## Current Plan to Add Alcohol to PC

# PC gas supply modifications

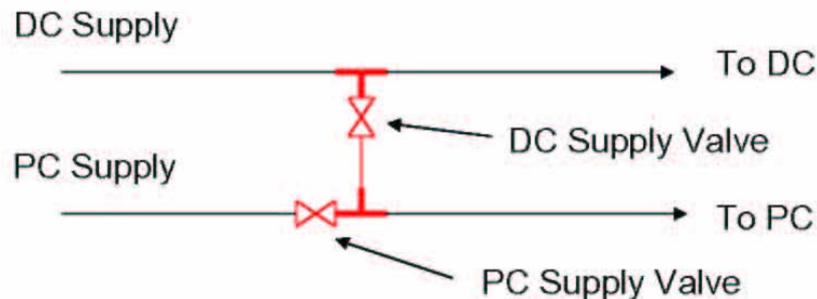
The current plan is to tap into the DC supply lines behind the East and West tracking chamber racks in the IR. Below is a drawing of how we plan to do this. Valves are being added to return the system back to its original configuration is needed. Actual photos are shown on the following 2 pages.
